# Access Compliance Report

## Public Rights-of-Way

### (Curb Ramps)

Intersection ID: 10038417	Main Street: SOUTH_REA_PARK_LN	Cross Street: N/A	Location:	N
ADA ID: DB3449D5DF1C	Ramp Type: Perp	Initial Pass/Fail: Pass	Overall Compliance: No	Severity Score: 5

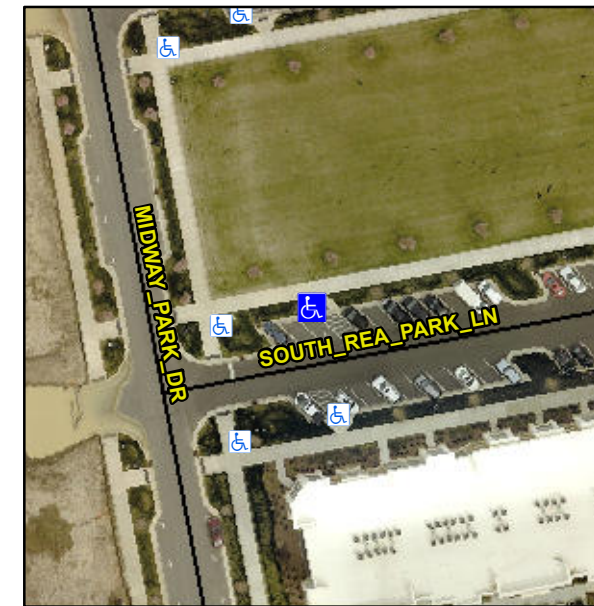
**R304.5.4**

**Remove & Replace Gutter.**
